INC. VILLAGE OF FREEPORT

November 28, 2023
AMENDED LETTER OF DENIAL

RE: **300 Archer St, Freeport, NY**
Zoning District – Res. A Sec. 62 Blk. 129, Lot 15
Building Permit Application #20233461
Description– Maintain Cabana with chimney 18 x 20 sq.ft

Site Plan

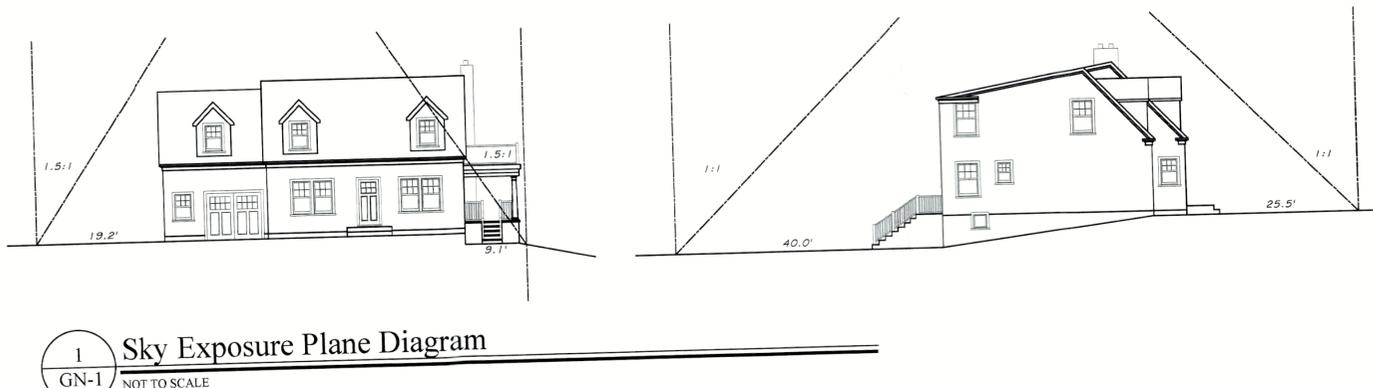
(3) Side yards width: minimum 10 feet; the sum of the width of the two side yards shall, at minimum, equal 25% of the lot width. According to the plans that you have submitted indicates that you have a side yard of 9.1 ft and 6.3 ft to cellar entry.
